SERVICE BULLETIN

APPLICABILITY: 2019-24MY Ascent

NUMBER: 12-260-25

SUBJECT: Loose Fitting A-Pillar Trim Panel

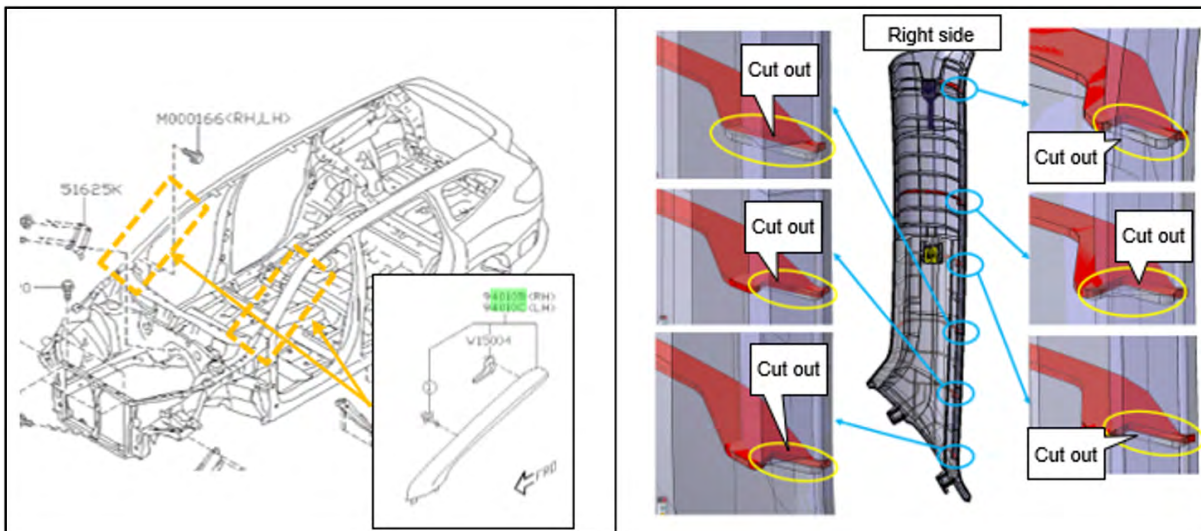
This bulletin announces the design change made to the left and right A-Pillar trim panels. This design change was developed to address cases of loose fitment. The internal ribs of the trim panels have been reshaped to prevent interference with the vehicle body. If A-Pillar trim panel loose fitment is confirmed, replace both A-Pillar trim panels with the parts listed in this bulletin.

Additional cut outs have been added to the internal ribs of the A-Pillar trim to provide better clearance and reduce any pressure against the vehicle body.

Part Description	Part Number
TRIM PANEL-A PILLAR, UPPER RIGHT	94010XC00CME
TRIM PANEL-A PILLAR, UPPER LEFT	94010XC01CME
